**Re: Proposed 15 x 20 Porch
Tax Map Parcel No. 36-28-62**

I have reviewed the submitted sketch plan identifying the existing dimensions of the improvements of the above referenced property and offer the following comments:

RICHLAND TOWNSHIP NOTICE OF DENIAL OF PERMIT

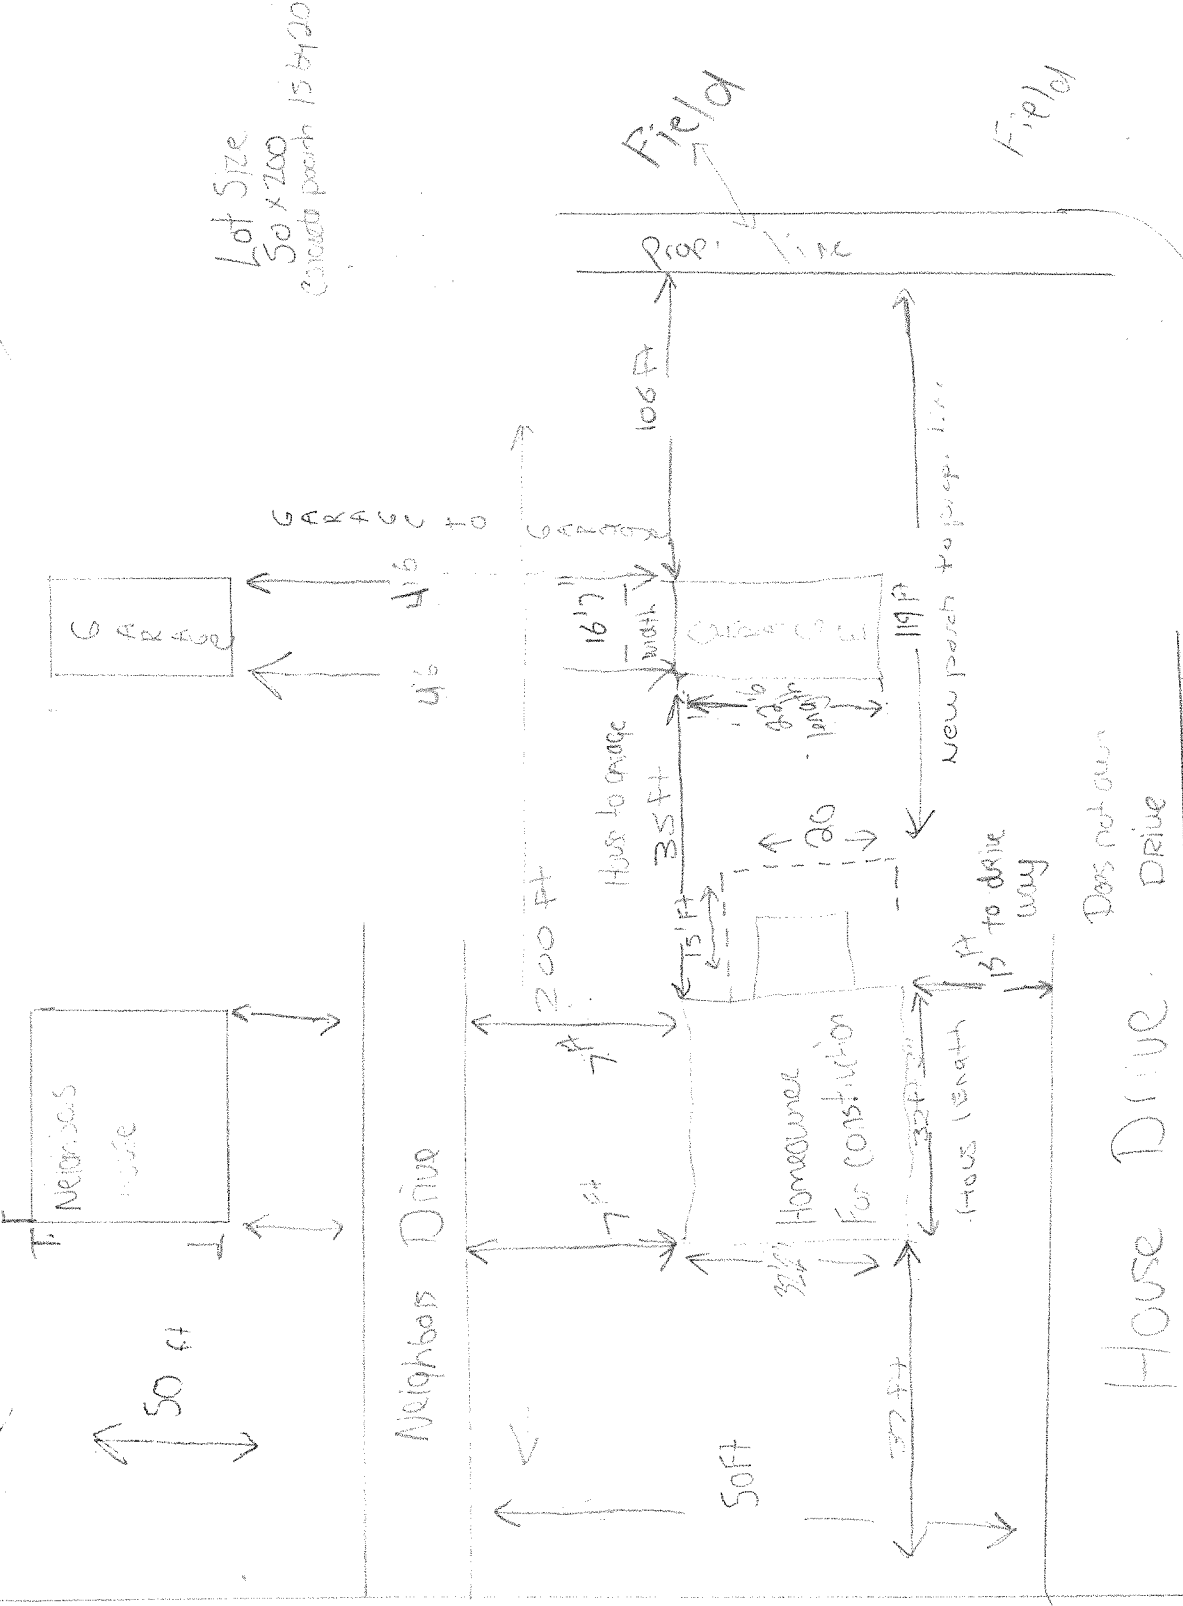
1. The property is located in the SRC Zoning District, and the use of the property is a B1 single family detached dwelling use.
2. The lot size as indicated is 50 x 200 10,000 sq ft. The maximum allowable building coverage is 10% percent and the maximum impervious surface allowable is 5% percent. It is noted, that the lot is nonconforming as it relates to the existing building and impervious coverages exceed both the maximum allowable building and impervious coverages, thus variances will be required.

If you would like to proceed with the submission of a Zoning Hearing Board application, please be advised, the sketch plan as submitted will not be sufficient for the hearing. You are required to have a plan completed by a Professional Engineer identifying the lot size, setbacks required for the zoning district, location of existing structures and improvements with the associated dimensions along with providing the site capacity calculations as defined in the Zoning Ordinance.
